## Addendum Submission

For the part retrospective retention of completed lakes Bridges and Puma, the retention and completion of part completed raised reservoirs Lakes 1, 2 and 3 (all for angling purposes) along with the clubhouse and detailed landscaping scheme at  
Monk Lakes, Staplehurst Road, Marden, Maidstone, TN12 9BS

0183/01  
Addendum Submission – Monk Lakes

Figure 2A

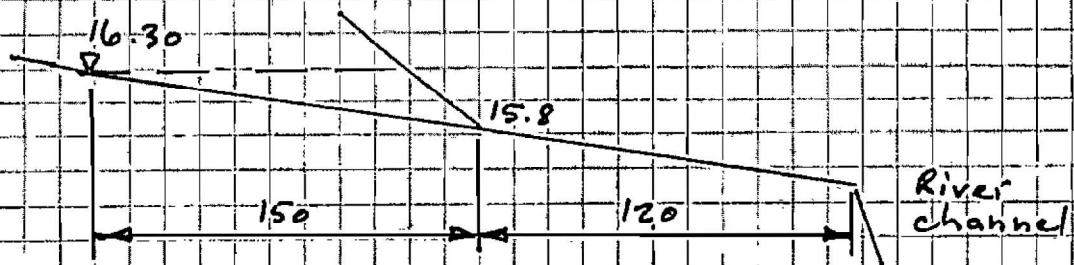
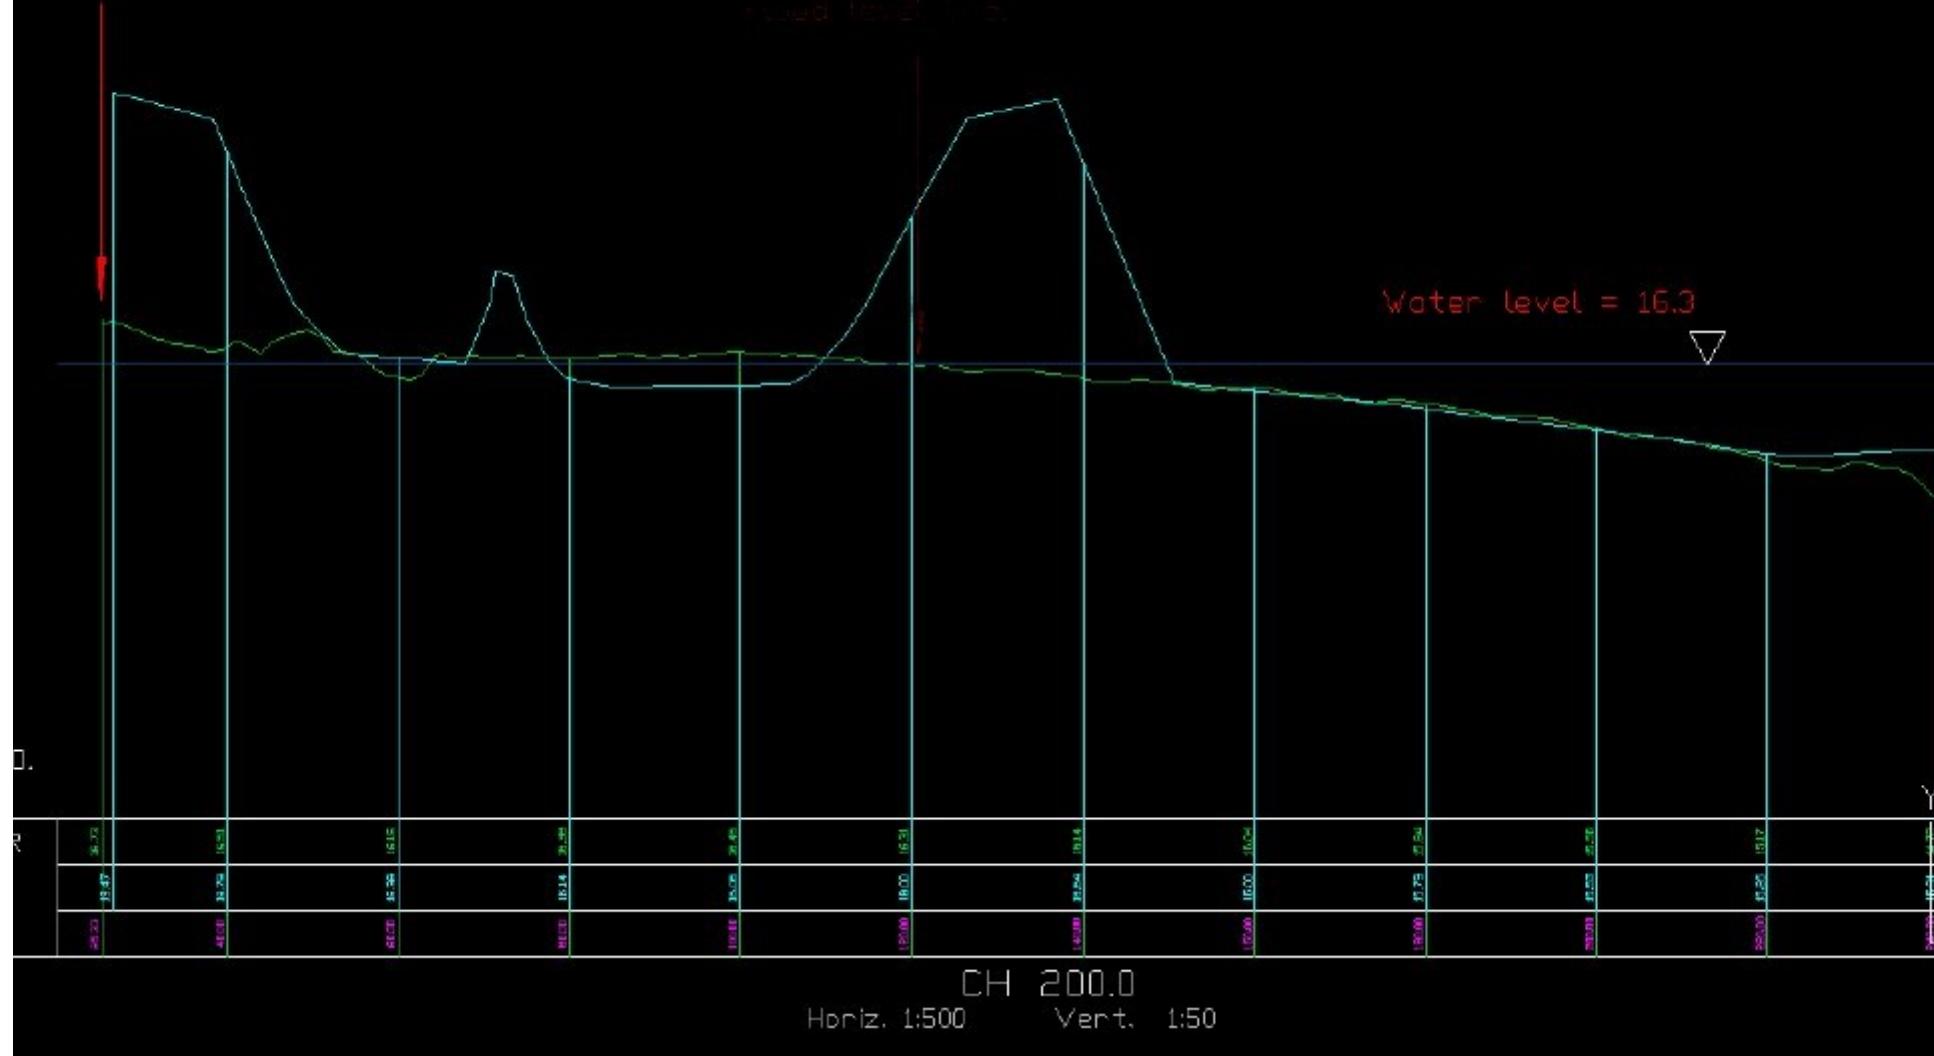
The previous estimate of flood storage loss through construction of Lake 3 was proposed by a Flood Risk Assessment (N Reilly, February 2012 (2012 FRA report)) which gave a volume of 30,200 m<sup>3</sup> (see attached Figure 2A, Section 7.3 and Appendix B of the 2012 FRA report). The 2012 FRA report does not include a detailed description of the method of calculation other than to say it represents a storage loss "between the levels of 15.4m and 16.3m AOD". The elevation of 15.4m AOD is assumed to represent pre-development ground levels and an elevation of 16.3m AOD relates to the 100-year plus climate change flood level established in 2011. Figure 2A of the report shows the location of the 2011 flood outline, which runs east – west along the southern side of Lake 3 (blue line in Attachment B). Appendix B of the 2012 FRA report appears to suggest the estimation of storage loss was determined from approximate values of the depth, width and length of Lake 3 that occupies the floodplain.

- 7.3 As noted above, the made ground for Lake 3 extends into the natural flood plain and there will therefore be a loss of flood plain storage as well as a loss of flow cross section. The amount of this storage loss has been assessed at 30,200 m<sup>3</sup> (see figure 2A) between the levels of 15.4 m and 16.3 mAOD. This is based on water level information and the indicative flood plain maps provided by the Environment Agency. It is proposed that this loss be compensated for by excavation of the car park area down to a level of 15.4 mAOD by Bridges Lake, rising to 16.3 mAOD on the approach road. This results in a fall of 1 in 226 across the car park area to provide for drainage. The volume of this up to the level of 16.3 mAOD is 15,600 m<sup>3</sup>. There is thus a small deficiency which is discussed further in section 7.5 below.

A revised estimate of flood storage loss through construction of Lake 3 has now been made which gives a volume of 3,662 m<sup>3</sup>. This has been determined using computer-aided design (CAD) software. The volume was arrived at by prismoidal calculations between two TINs (Triangular Irregular Networks). The two surfaces represent pre-development ground levels sourced from a 2002 LiDAR survey (cyan line in Attachment B) and the 'as built' Lake 3 ground levels sourced from a survey drawing (Reference Aworts 5881) created in September 2019 (green line in Attachment B). The areal extent of the volume calculation has been confined to the east, west, north and south by the western edge of Puma Lake, a ditch along the west edge of Lake 3, the southern bank of River Beult and the 2011 Flood Line from Figure 2A in the 2012 FRA report, respectively.

A comparison of the flood storage loss volume obtained from design calculations in the 2012 FRA report ( $30,200 \text{ m}^3$ ) with that obtained from the 'as-built' survey in 2019 ( $3,662 \text{ m}^3$ ), shows a substantial decrease in the actual flood storage loss caused by construction of Lake 3. Ground level profiles suggest that flood storage loss is restricted to a small part of the northern embankment and that much of the lake has been constructed at or above the 2011 flood level.

I Site Layout Plan 0183 04 02

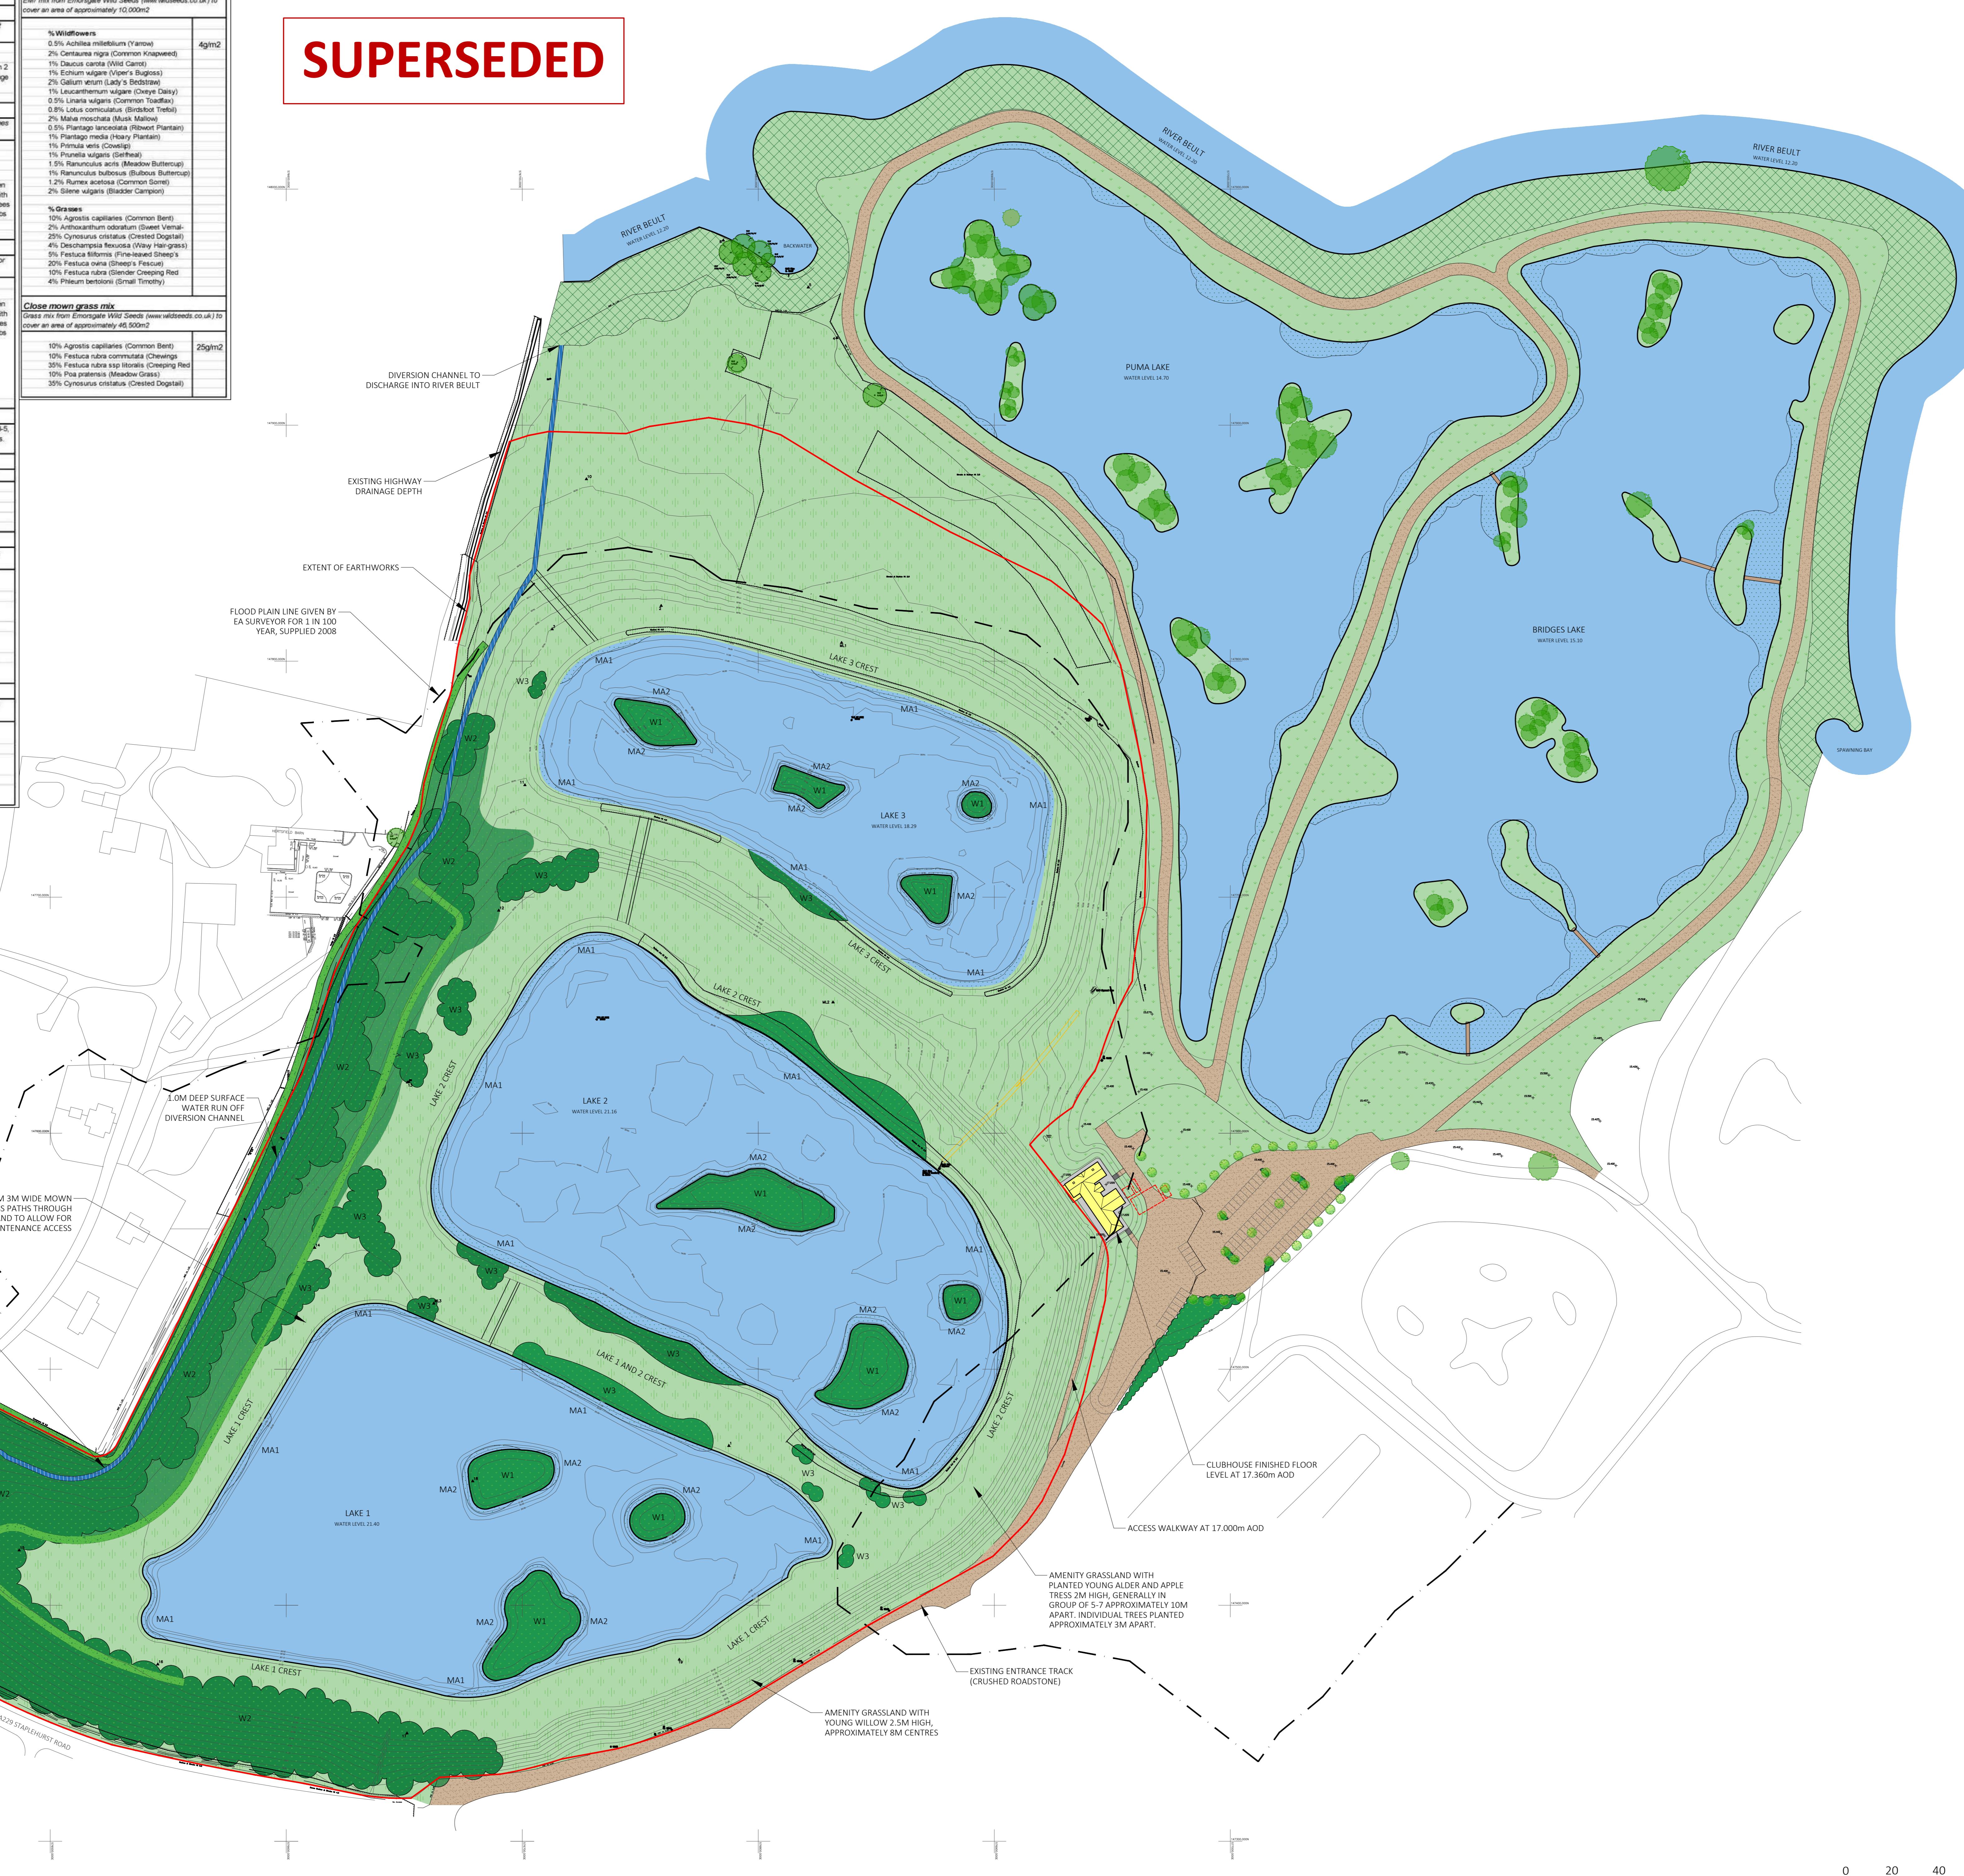
**B** CARPARK LEVELS AMENDED RL 04/10/19

**A** CLUBHOUSE ORIENTATION AND POSITIONED CHANGED RL 04/10/19

II Landscaping Plan 0183 04 03

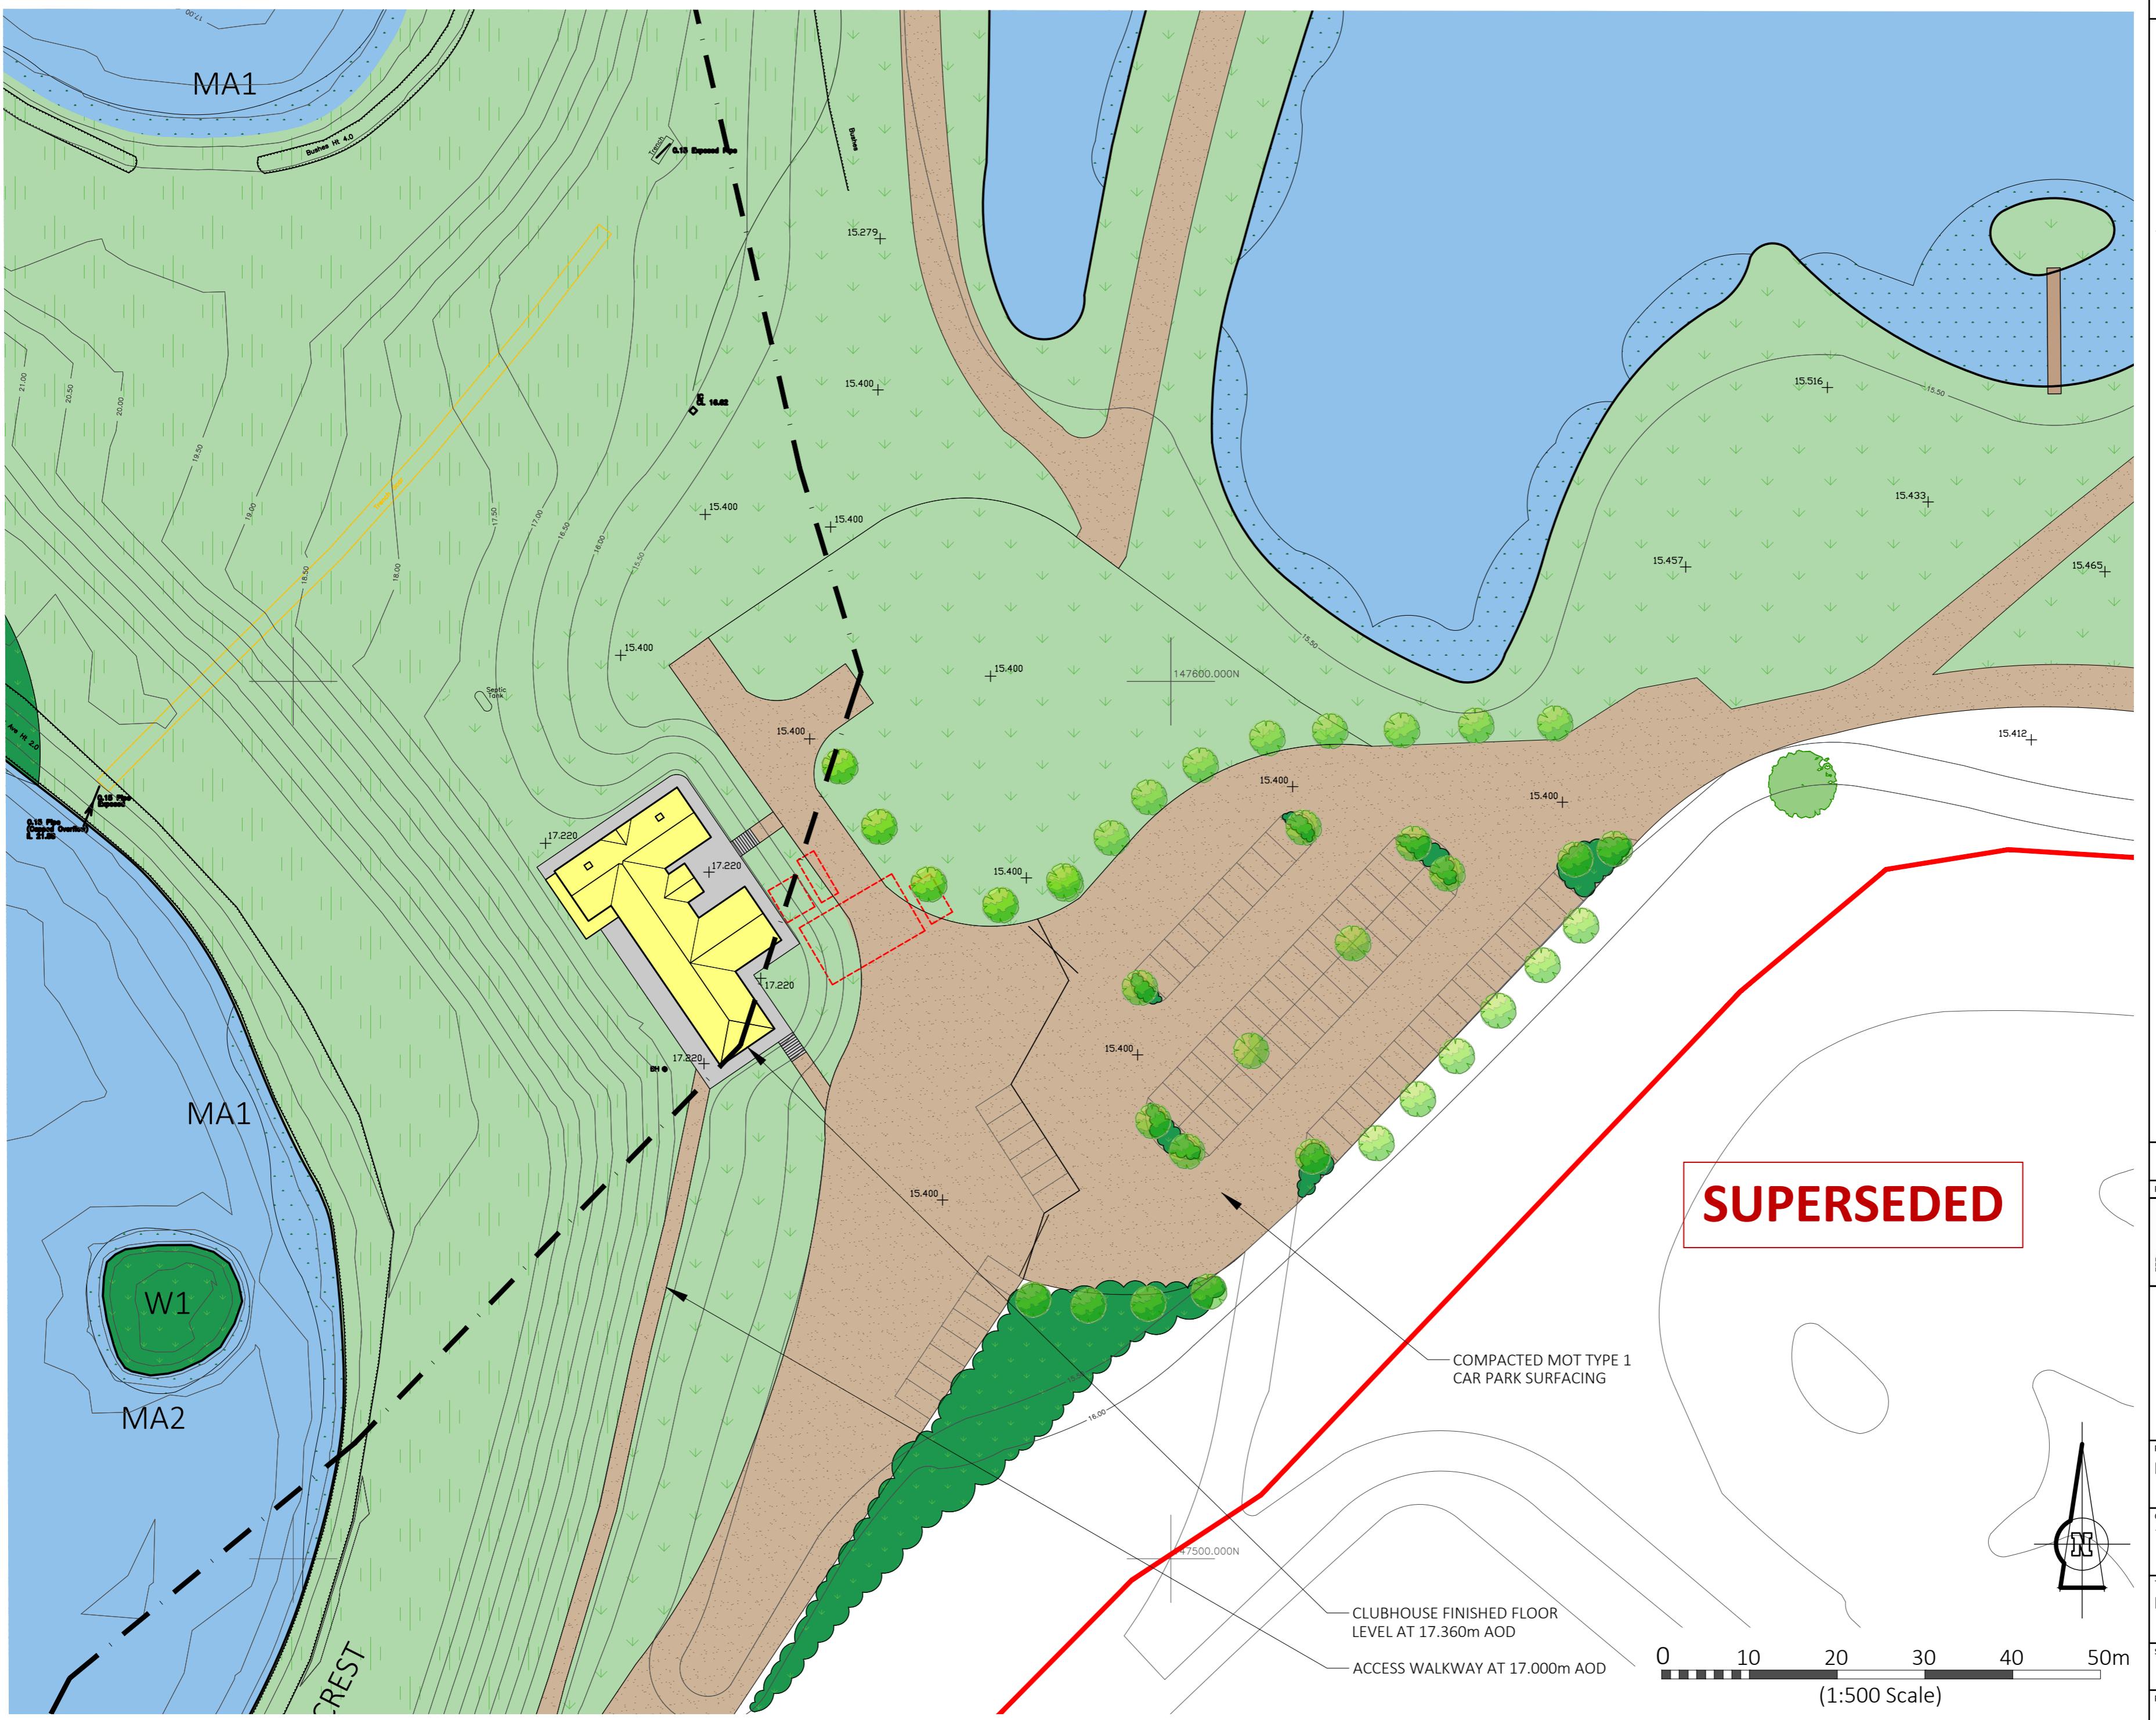
A CLUBHOUSE POSITION AND ORIENTATION, CARARK LEVELS ARRANGED	RL 04/10/19
REV: DESCRIPTION:	BY: DATE:
<b>NEXT PHASE</b> THE TOWN PLANNING EXPERTS	
HEAD OFFICE 6 Boni Street, Lichfield, Staffordshire, WS13 6LL tel: 01543 571718	
LONDON OFFICE 16 Upper Weburn Place, London, WC1H 0BS tel: 020 3741 8225 <a href="http://www.nextphasedevelopment.co.uk">www.nextphasedevelopment.co.uk</a>	
PROJECT: Monk Lakes	
CLIENT: Tynte Ltd.	
TITLE: Proposed Landscaping Plan	
SCALE AT A: 1:1000   DATE: 27/09/19   DRAWN BY: CW   CHECKED BY:	
PROJECT NUMBER: 0183-04   DRAWING NUMBER: 0183-04/03   REVISION: A
